HISTORIC AND DESIGN REVIEW COMMISSION

Agenda Item No: 22

HDRC CASE NO: 2016-459
ADDRESS: 1008 BURNET ST
LEGAL DESCRIPTION: NCB 1660 BLK H LOT N 166 FT OF 2 & W 25 FT OF 3
ZONING: RM-6 CD H
CITY COUNCIL DIST.: 2
DISTRICT: Dignowity Hill Historic District
APPLICANT: Luis Gerlein
OWNER: Luis Gerlein
REQUEST:

The applicant is requesting conceptual approval to construct five, two story houses on the vacant lot at 1008 Burnet.

5. MATERIALS

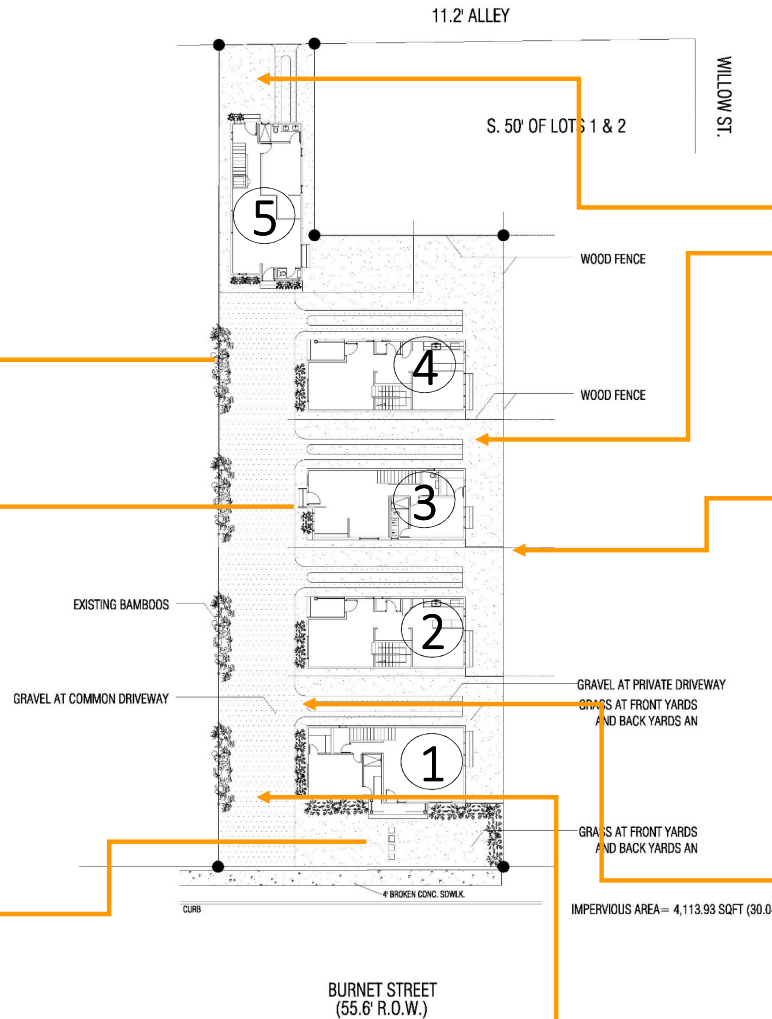
- r. LANDSCAPING – The applicant has provided a landscaping plan; however, the provided landscaping plan does not include specifics on landscaping materials. Staff recommends the applicant provide additional information regarding landscaping materials.

CARPORT DETAIL - SECTION

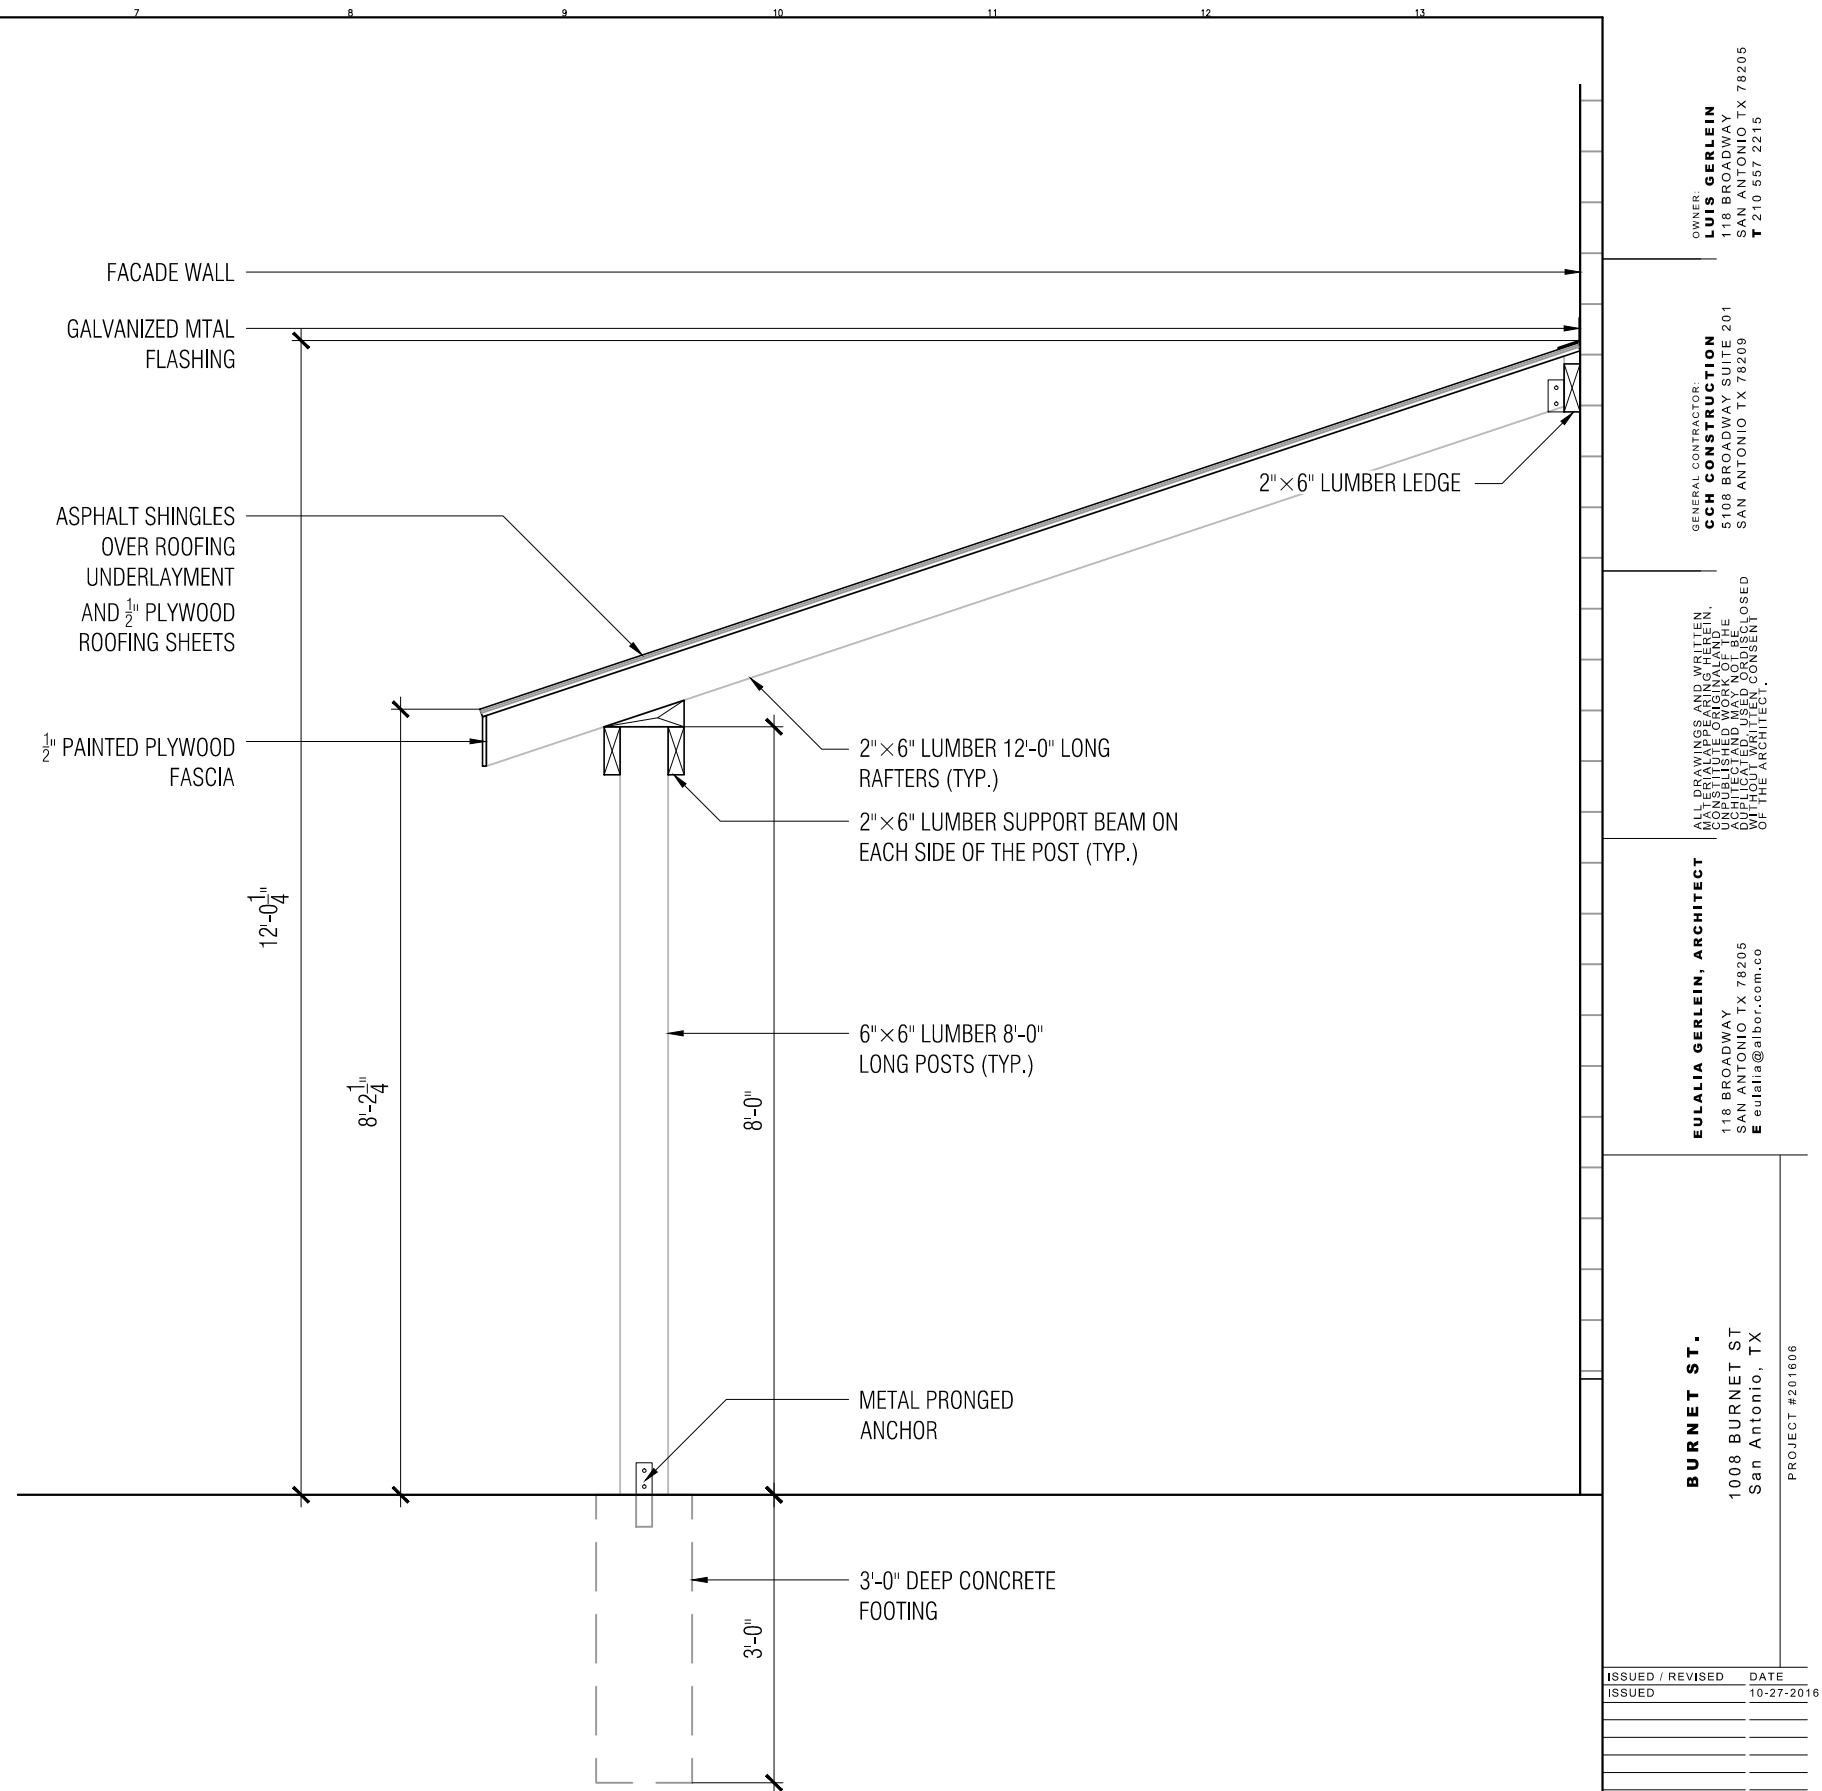
- m. CARPORTS – To the south of each structure, the applicant has proposed to construct an attached carport. Staff finds the installation of carports appropriate. The proposed carports feature an overall massing that is appropriate; however, staff finds the proposed carport columns to be architecturally inappropriate.
